subject: Paramount Palm Beach Traffic Review

MEMORANDUM

The Corradino Group, Inc (Corradino) has been requested to provide a traffic review of the Traffic Impact Evaluation for the redevelopment of the Paramount Theatre located at 139 North County Road in the Town of Palm Beach, Florida. The following are our traffic review comments based on the 11/20/23, 12/07/23 and 12/21/23 resubmittals.

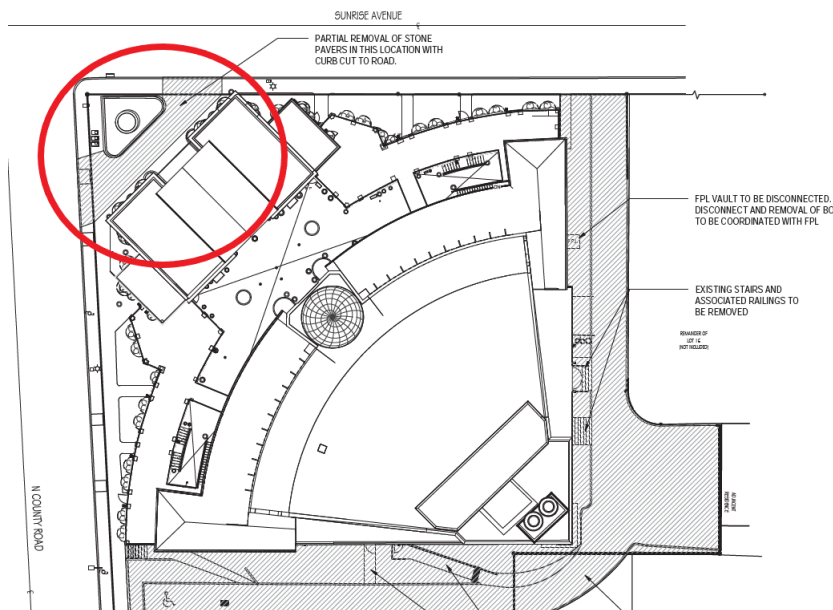
12. Please provide additional narrative that provides the total amount of queuing available from the valet stand to the adjacent road network for both scenarios. Figures 3 and 4 should be updated to denote the total amount of queuing available from the valet stand to the adjacent road network.

Kimley Horn and Associates, Inc.'s 03/09/23 Response Additional information is provided in the updated report and Figures 3 and 4 illustrating the queuing available to the adjacent road network. Note that the valet stand for the event space is proposed to be located on North County Road.

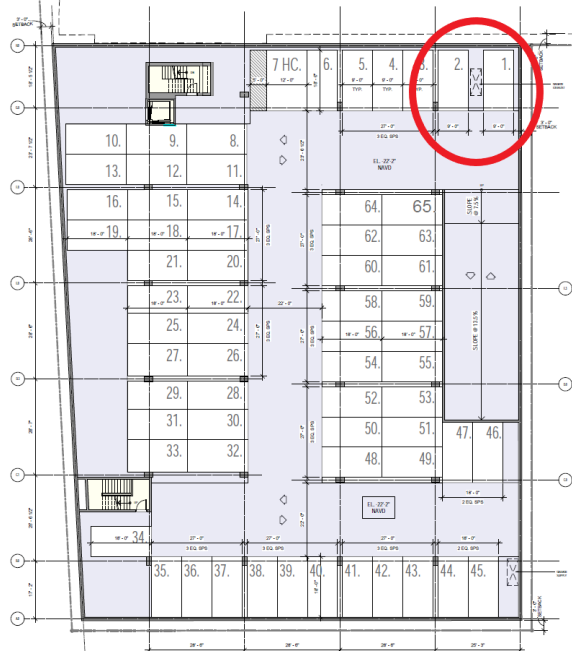
18. Please include a copy of the raw traffic counts from 11/29/22 in the Appendix of the updated traffic impact study. This traffic count data was not included as part of the traffic impact study dated 03/09/23. The Town of Palm Beach recently collected peak hour manual turning movement counts on 02/28/23 at the following three signalized intersections analyzed for the Paramount Palm Beach development:

1. Sunrise Avenue & N County Road
2. Sunset Avenue & N County Road
3. Royal Poinciana Way & N County Road

Please cross check the intersection capacity analysis completed as part of the updated traffic impact study utilizing this current traffic count data (copy of count data has been attached). Please update all tables and figures as necessary.

Kimley Horn and Associates, Inc.'s 04/18/23 Response: A copy of the raw traffic counts from 11/29/22 has been added to the Appendix. The two sets of traffic counts were compared, and there was not an overall consistent pattern between the two sets: volumes on some movements were lower, and volumes on other movements were higher when comparing the AM and PM volumes. Therefore, the Synchro analyses were not modified.
